RENAISSANCE
CÉNTRO

**Re: Zoning Determination Letter
 2109 M Street NW – Square 70, Lot 880 (part of record lot 190)**

Thank you for meeting with us to review the current development plans for 2121 M Street NW and confirm (or in some cases, reconfirm) the application of the Zoning Regulations. The property is located in Square 70, Lot 880 (part of record lot 190) ("Property") in the CR Zone District. We propose to construct a hotel with 168 rooms, some ground floor retail and function room spaces, and 34 parking spaces, as shown on the attached plans ("Project").

From: Avitabile, David
Sent: Sunday, November 10, 2013 12:32 PM
To: 'Ndaw, Mamadou (DCRA)'
Cc: 'LeGrant, Matt (DCRA)'; Epting, John; 'Ilan Scharfstein'
Subject: 2121 M Street (B1310607) - Response to Zoning Review Comments
Attachments: RE: 2121 M Street -- Review of our discussion; 2121 M Street -- Review of our discussion; Determination Ltr re 2109 M St to Epting 12-6-2010.pdf; At-Grade Connections.pdf; Valet Parking Plan.pdf; Hyatt Place M Street Rooftop Structures .pdf; Hyatt Place M St Site Plan - loading.pdf

Public Space Plan

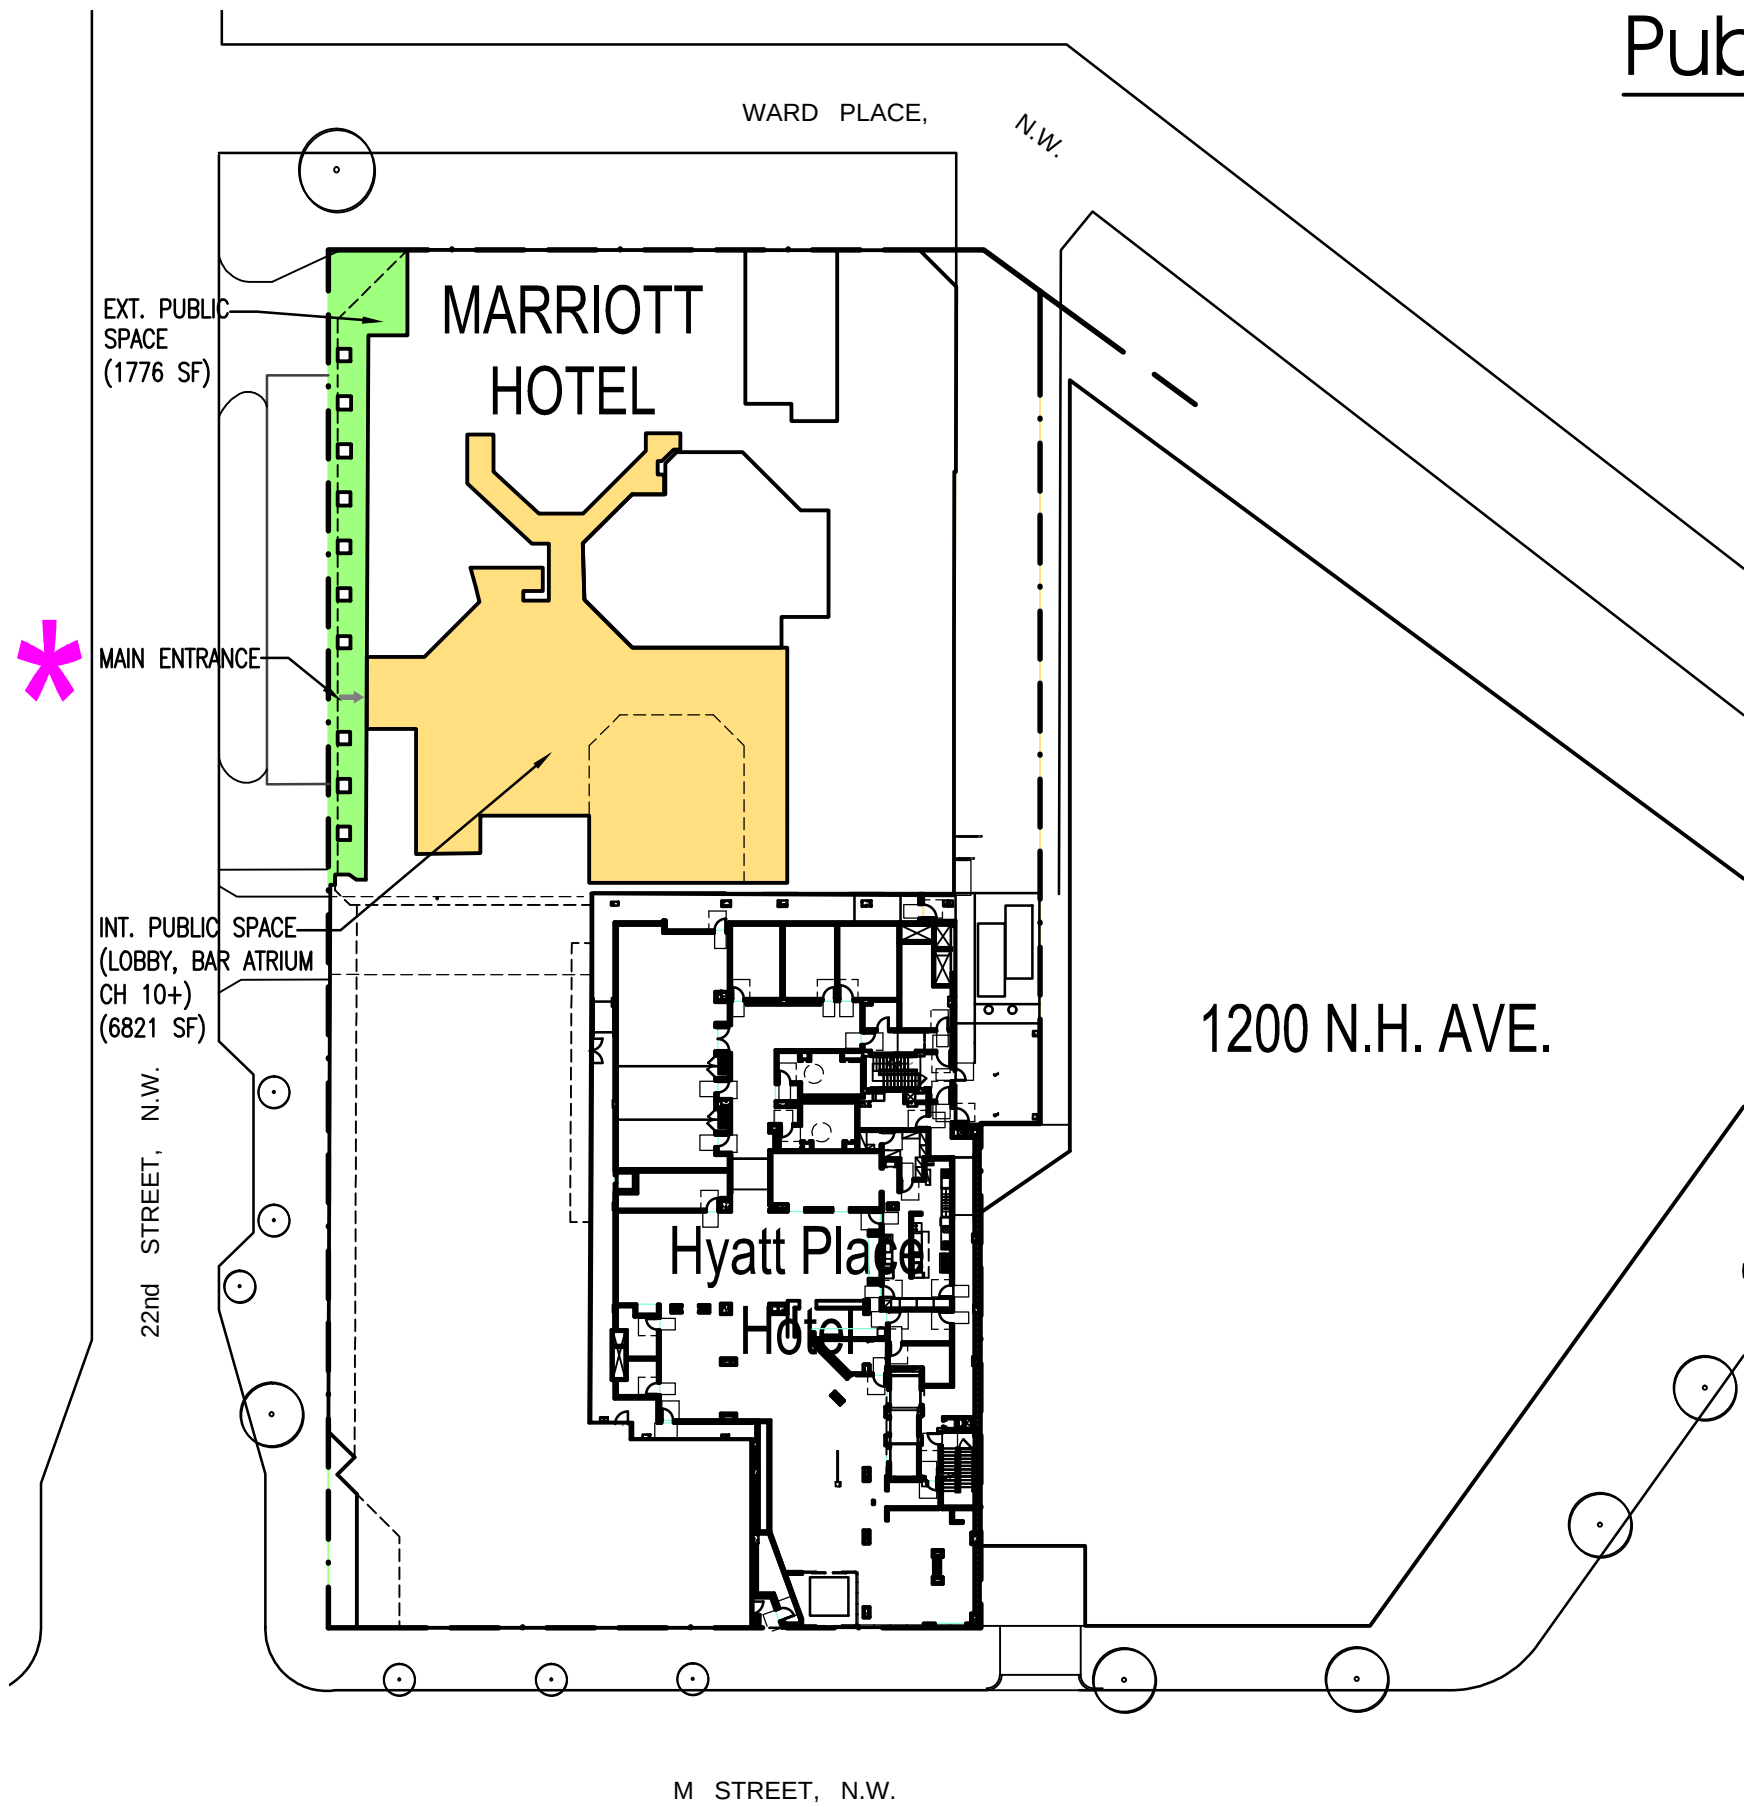
I also add that the public space at ground level is required to be adjacent to the main entrance of the principal structure. Therefore, the public space requirement must have been met by space adjacent to the Marriott's main entrance on 22nd Street. The portion of the record lot that is our property could have never been the required public space at ground level.

- Accordingly, you agreed that the requirement for public space at ground level has been met, and no further public space at ground level is required for the Project.

1st FLOOR PLAN

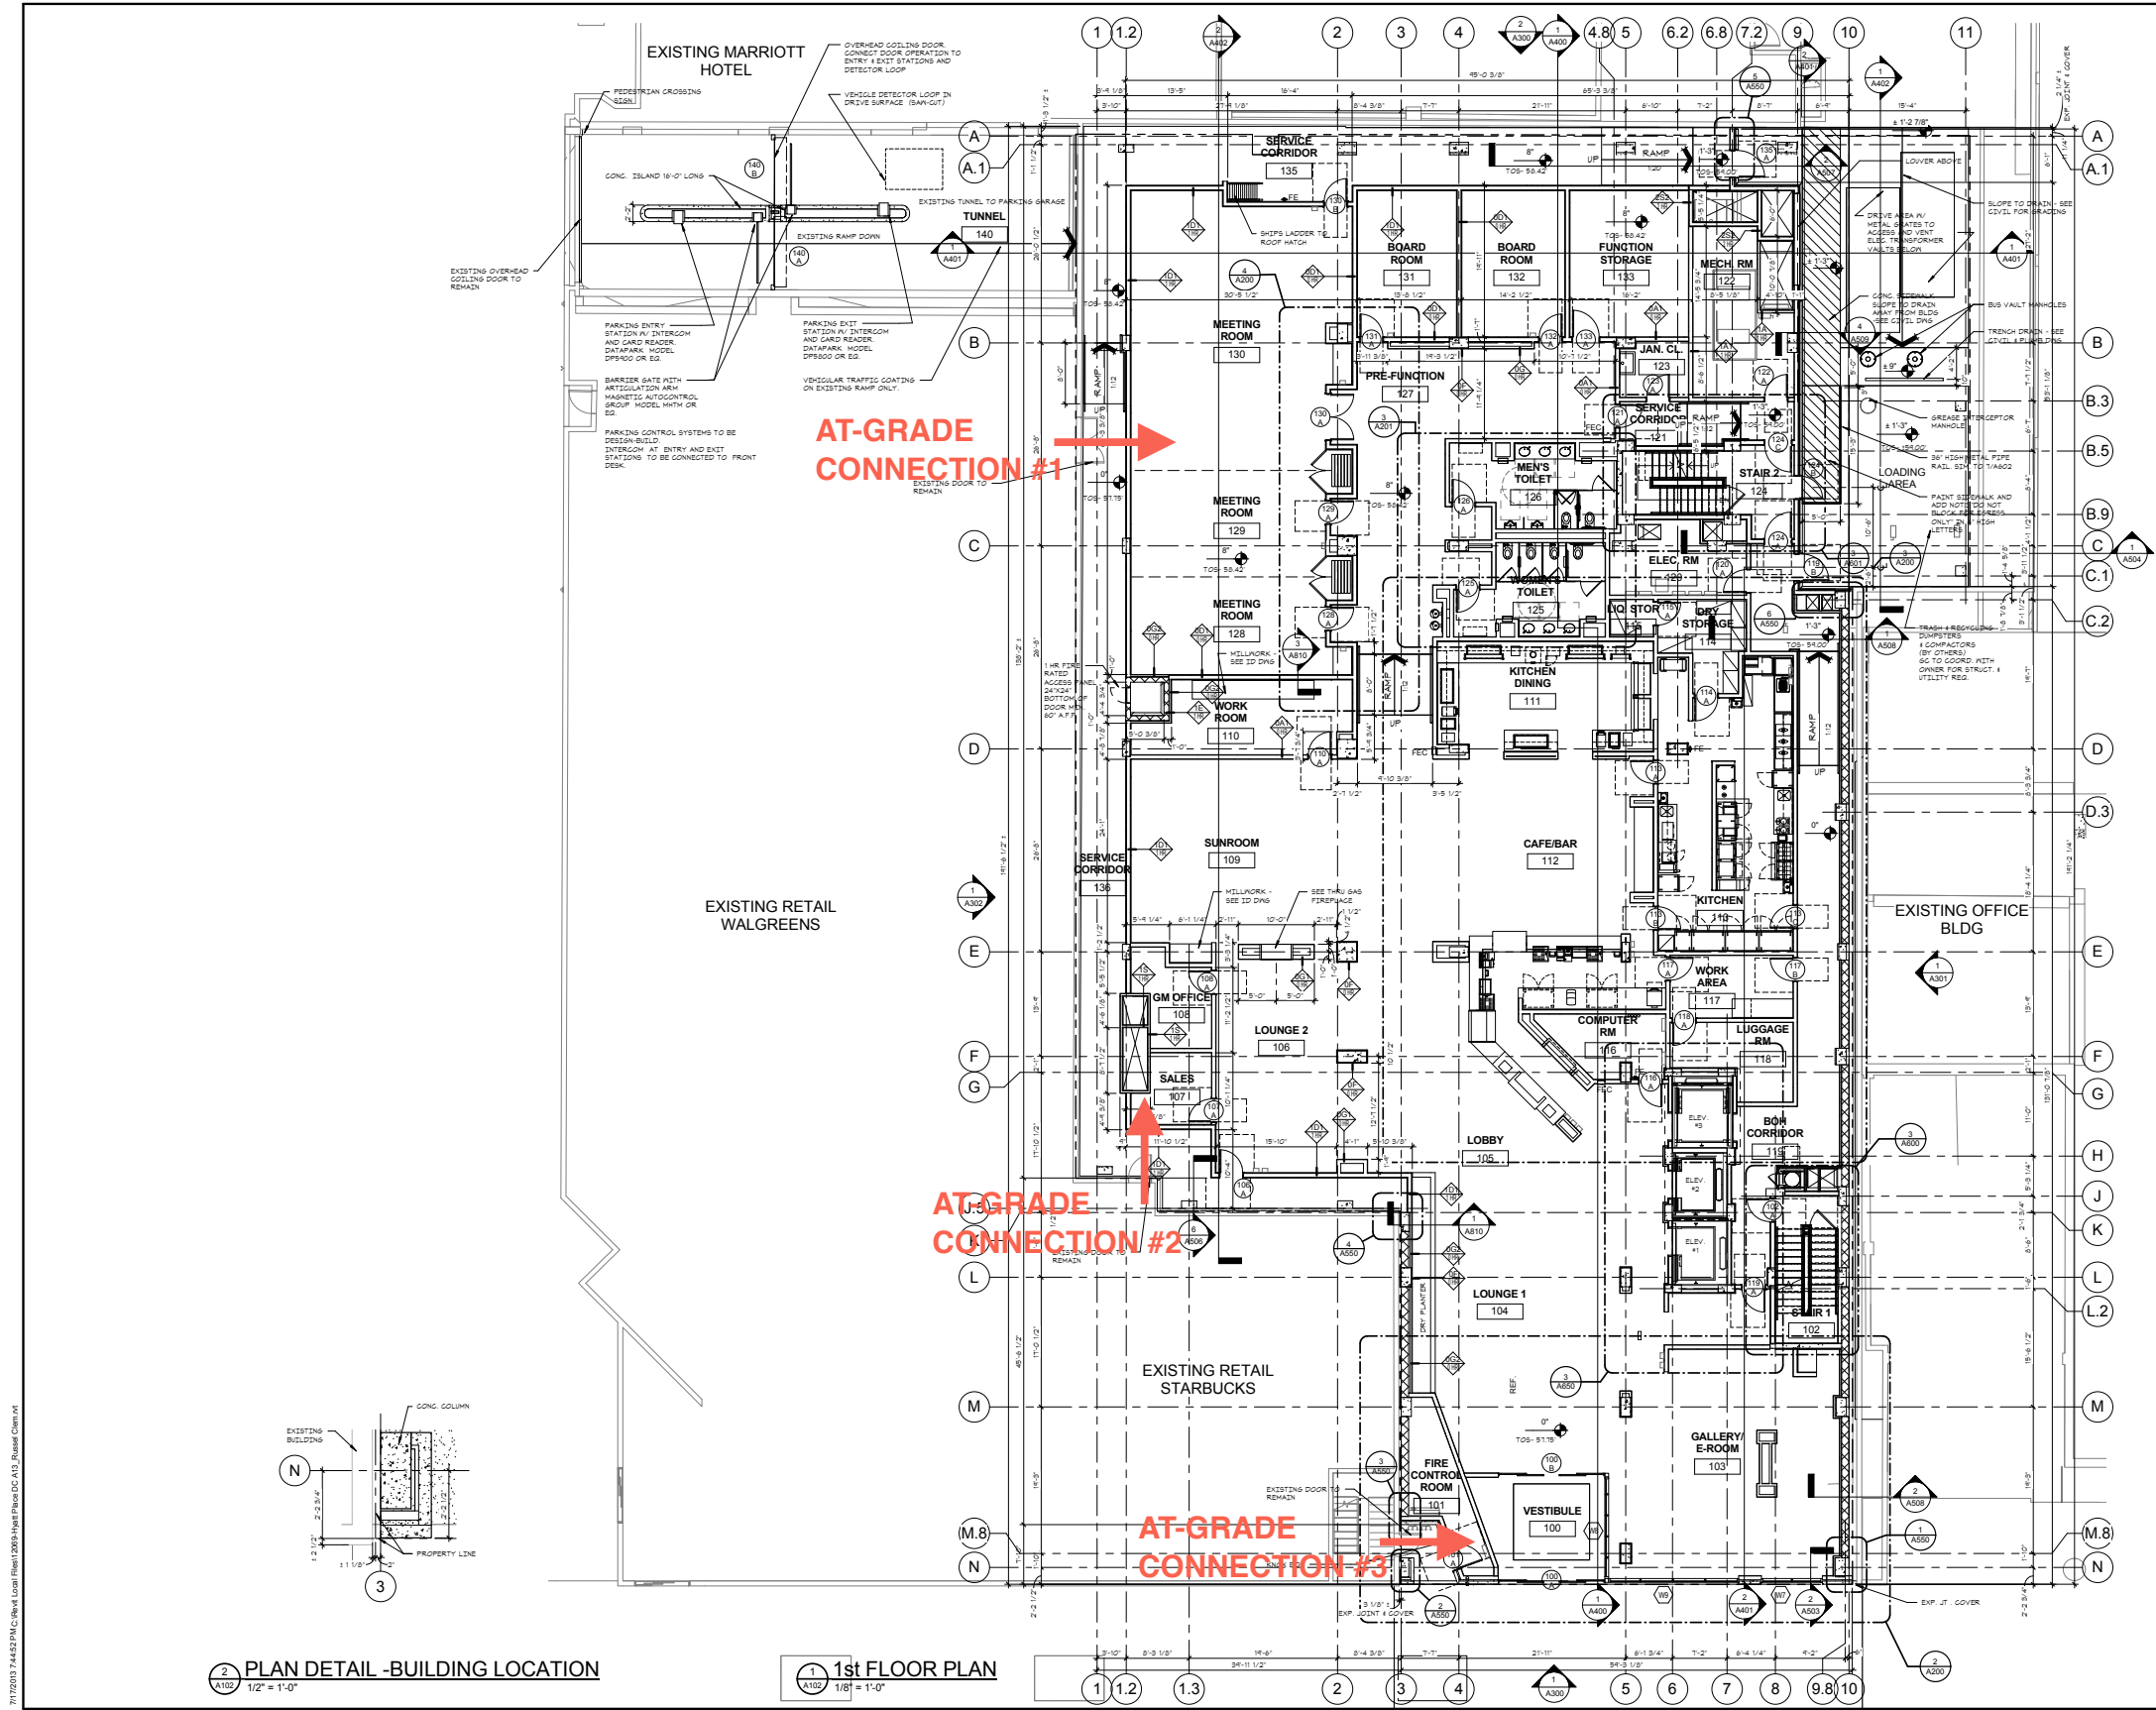
1. Please apply for a subdivision to convert the tax lot into a record lot. 2. Please explain what "addition to the existing Washington Marriott Hotel" means. Is the new hotel a separate entity from the Washington Marriott Hotel? If not please contact me by email before resubmitting the plans.

This was confirmed in our July 2013 meeting with Matt and is described in our August 2013 letter to Matt. Our property (Lot 880) is located on the same single record lot as the Washington Marriott and some ground floor retail establishments. Our Project will be connected to the other structures on the record lot through (a) the Marriott's hotel stair tower, which will exit into a vestibule within our building before discharging people out to M Street and (b) through doors at the rear of the retail spaces that provide access through and across a corridor on our parcel to the rear loading area and private alley. These connections are at street level and are therefore at or above the main floor of the

structures. Accordingly, Matt confirmed the structures will constitute one building for zoning purposes. For your convenience, I've marked up the ground floor plan to call out the at-grade connections described above.

1 ROOF TERRACE PLAN
A111 1/8" = 1'-0"

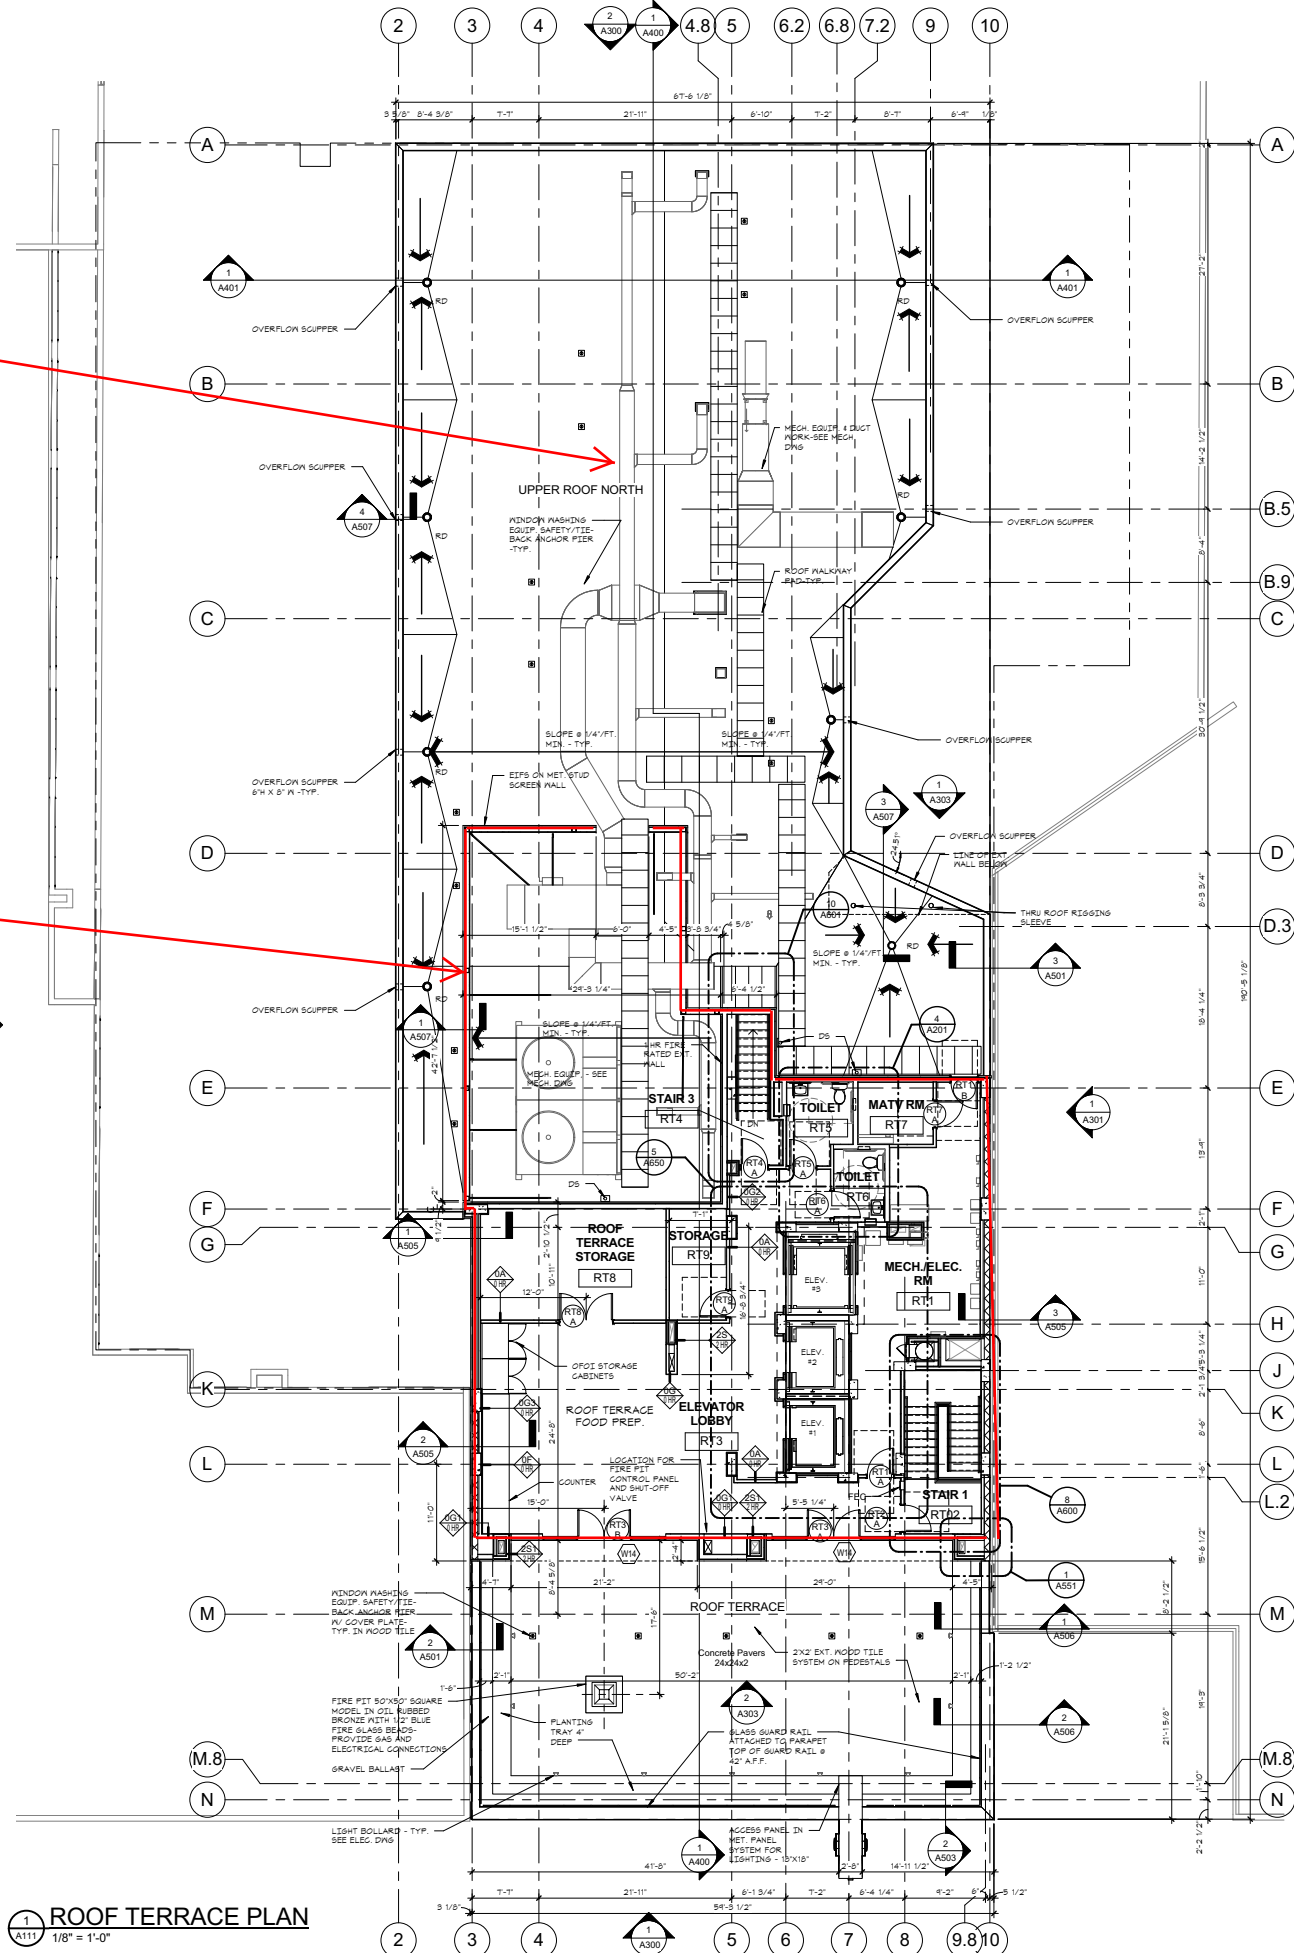
Please see attached for the whole roof plan and then a second page outlining the outdoor terrace and the interior accessory space. The outdoor terrace (B) is 1,687 s.f., and the interior space (A) is 480 s.f. This means that the interior space is 28-29% of the exterior space – however, our client noted that this is a function of the lot size and building configuration, which limits the size of the exterior space. In the absolute, the 480 s.f. interior space is small.

Thanks for the clarification, as well as illustrative plans that were attached to your email. By this email I am confirming my agreement with its analysis, and its conclusion that the areas of the rooftop structure comply with Section 411 of the Zoning Regulations.
